# Access Compliance Report

## Public Rights-of-Way

### (Curb Ramps)

Intersection ID: 14461	Main Street: E_WORTHINGTON_AV	Cross Street: LYNDHURST_AV	Location: W
ADA ID: 7CFB4C986EE2	Ramp Type: Perp	Initial Pass/Fail: Fail	Overall Compliance: No
Severity Score: 42.5			
Codes/Mitigation Info/Possible Solution		Field Measurements/Component Compliance

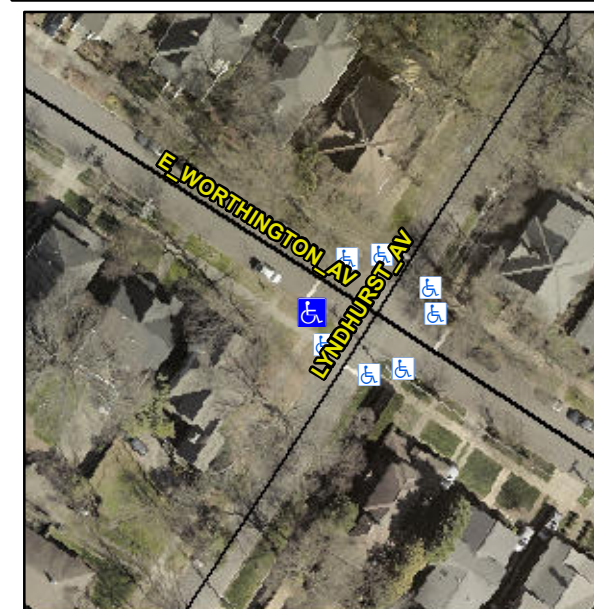
**Not Found, R304.5.1, R304.2.2, R304.5.3**

Compliance	Description	Data	Compliance	Description	Data
N/A	Ramp Length (in)	101.0	No	Ramp Slope (%)	10.8
No	Ramp Width (in)	32.0	No	Ramp XSlope (%)	6.1
N/A	Flare Type LT	N/A	N/A	Flare Type RT	N/A
N/A	Flare Slope LT (%)	N/A	N/A	Flare Slope RT (%)	N/A
N/A	Flare Traversable LT?	N/A	N/A	Flare Traversable RT?	N/A
N/A	Landing Length (in)	N/A	N/A	DWS Provided?	N/A
N/A	Landing Width (in)	N/A	N/A	DWS Contrast?	N/A
N/A	Landing Slope (%)	N/A	N/A	DWS Length (in)	N/A
N/A	Landing X Slope (%)	N/A	N/A	DWS Full Width?	N/A
N/A	Landing Curb? (Y/N)	N/A	N/A	DWS Offset (in)	N/A
N/A	Shared Landing?	N/A			
N/A	Gutter Ponding?	N/A	N/A	Gutter Slope (%)	N/A
N/A	Gutter Lip Ht (in)	N/A	N/A	Gutter X Slope (%)	N/A
N/A	Painted X Walk1?	No	N/A	Painted X Walk2?	N/A
	X Walk 1 Direction	To NE		X Walk 2 Direction	N/A
N/A	X Walk 1 Width (in)	N/A	N/A	X Walk 2 Width (in)	N/A
	X Walk 1 Slope (%)	6.4		X Walk 2 Slope (%)	N/A
	X Walk 1 X Slope (%)	1.2		X Walk 2 X Slope (%)	N/A

**Remove & Replace Entire Ramp.**
